ADDENDUM No. __2__

Date: March 15, 2016

Project Name SAR WWTP Trains A & B Blower Replacement

C.I.P. No. 3333.028 IFB No.: 6100 CLMC 573

JOB NO. 9469B.10
DRAWING NO. 01C02
SHEET NO. 96 OF 320

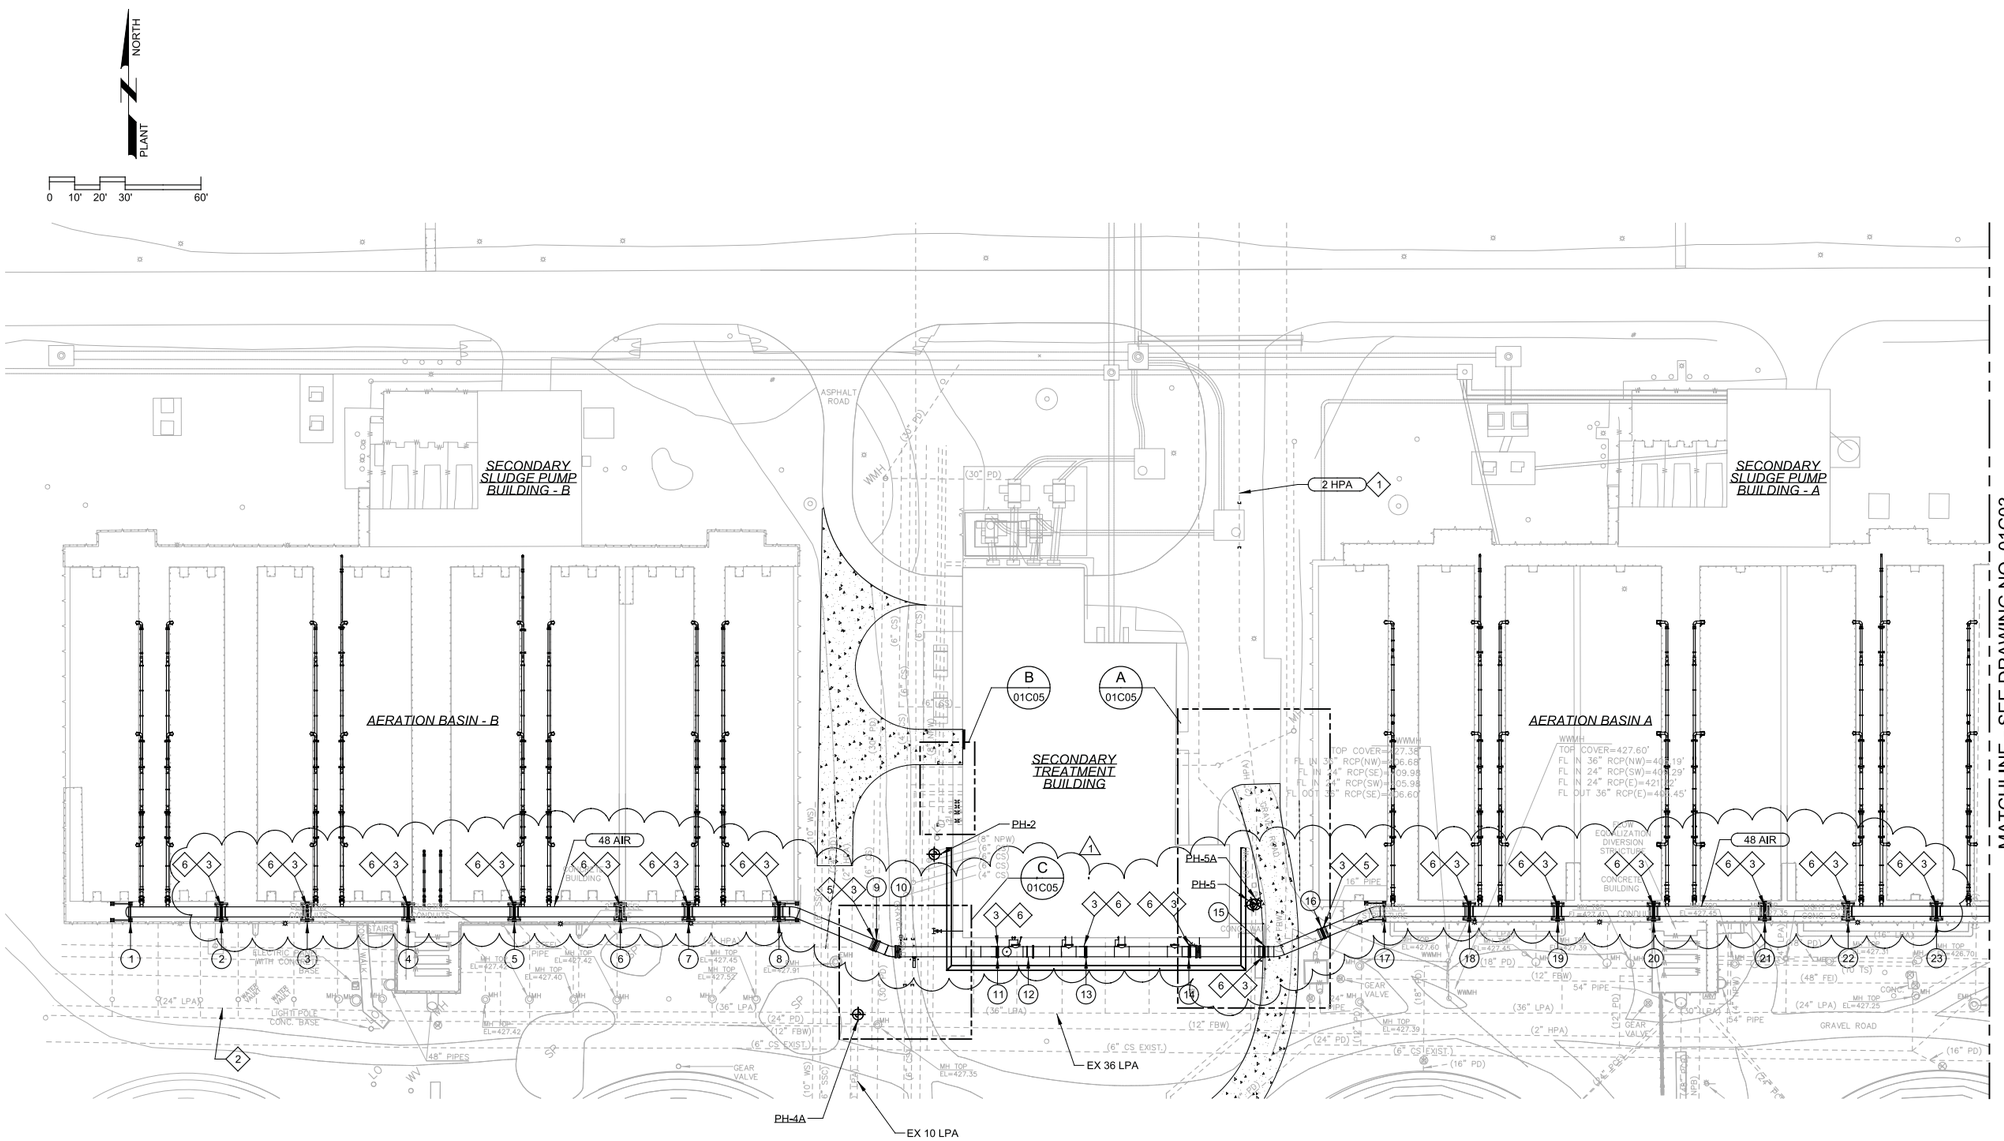
2. VOLUME 6, Sheet 96 of 320, Drawing 01C02:

REPLACE Drawing in its entirety with the attached Drawing.

JOB NO. 9469B.10
DRAWING NO. 01S02
SHEET NO. 123 OF 320

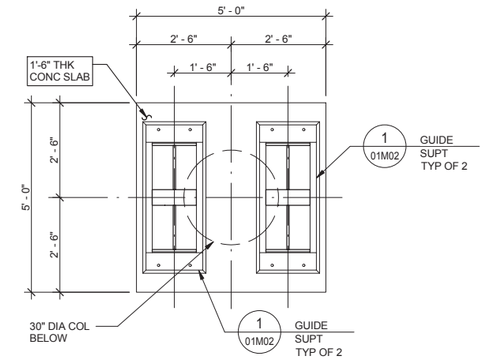
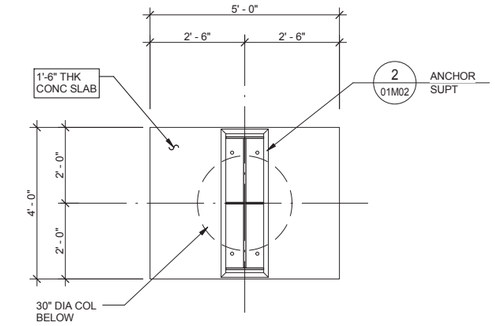
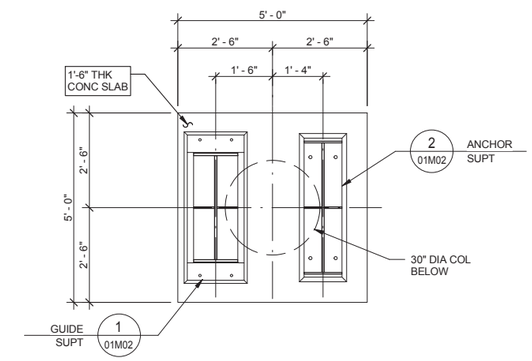
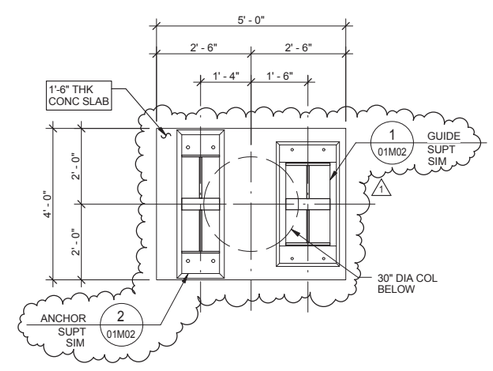
REPLACE the reference to C (01S02) with D (01S02) for the following supports: 14, 27, 31, 32, 34, 35, and 37.

REPLACE the reference to C (01S02) with A (01S02) for the following supports: 29 and 38.

6. VOLUME 6, Sheet 123 of 320, Drawing 01S02:

REPLACE Drawing in its entirety with the attached Drawing.

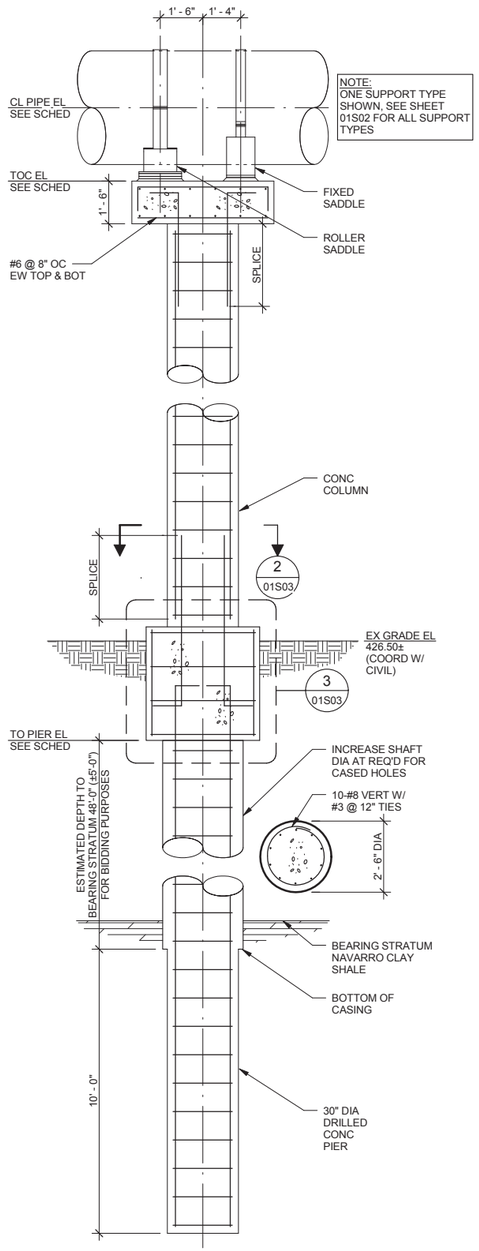
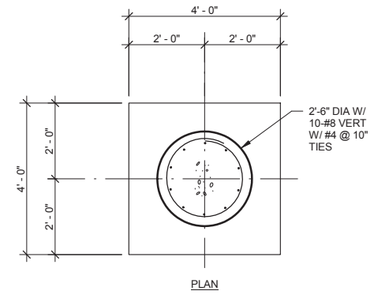
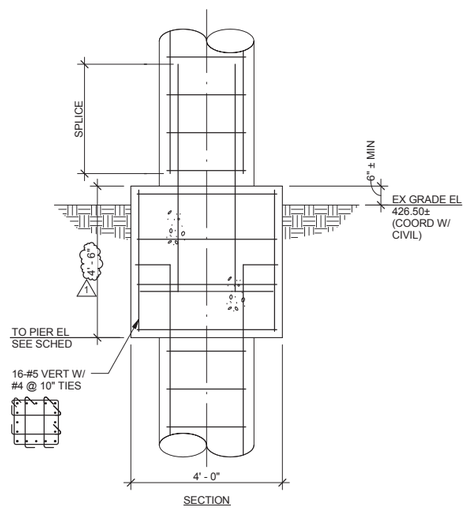
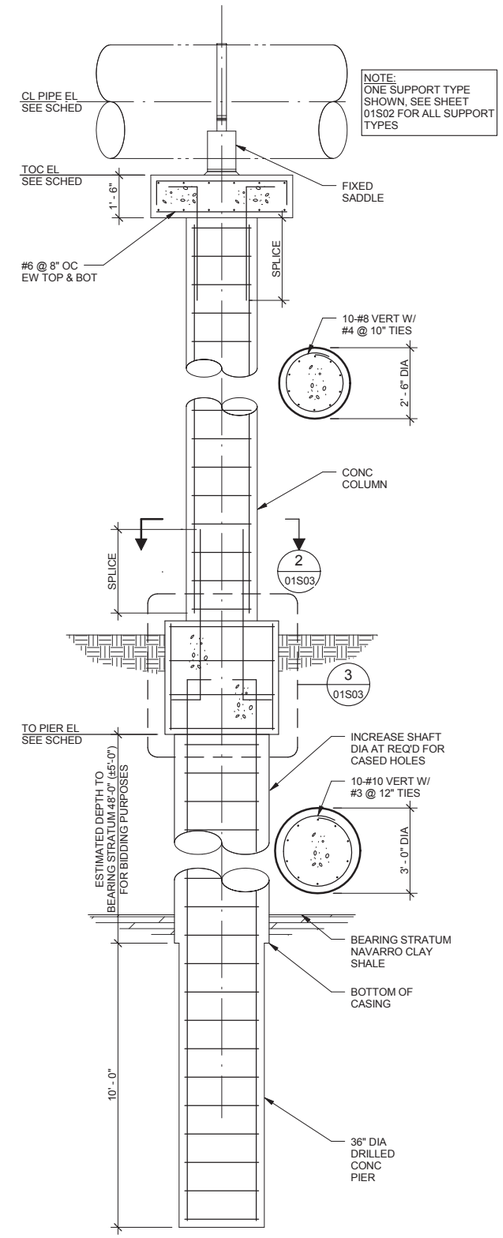
7. VOLUME 6, Sheet 124 of 320, Drawing 01S03:

REPLACE Drawing in its entirety with the attached Drawing.
